## SERVICE LETTER 143

### 2100A, 2350A MAIN LANDING GEAR PROXIMITY SWITCH

<b>By:</b> MAB	<b>Aircraft Makes/Model(s):</b>  N/A	<b>Float Model(s):</b>  2100A 2350A	<b>Note(s):</b>  Mandatory Compliance Service Letter P/N 1005934
<b>Approved:</b> SDW			
<b>Date:</b> 10/17/2019			
<b>Revision:</b> E

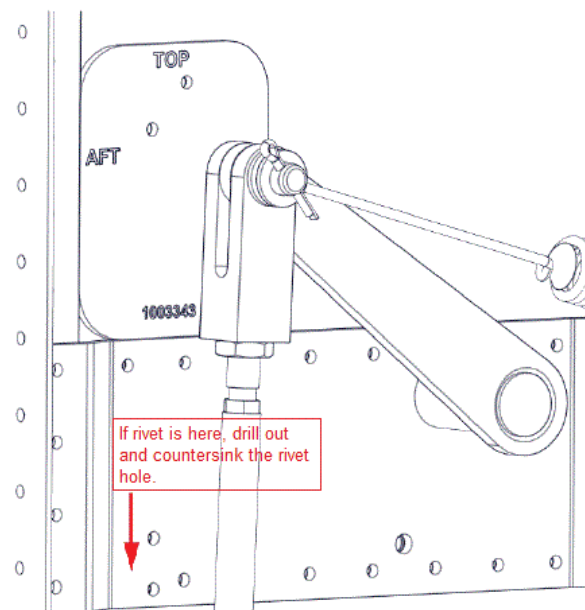
9. Remove 1005933 proximity switch location drill template and drill out the rivet shown. Countersink the rivet hole and reinstall rivet so it is flush on both sides
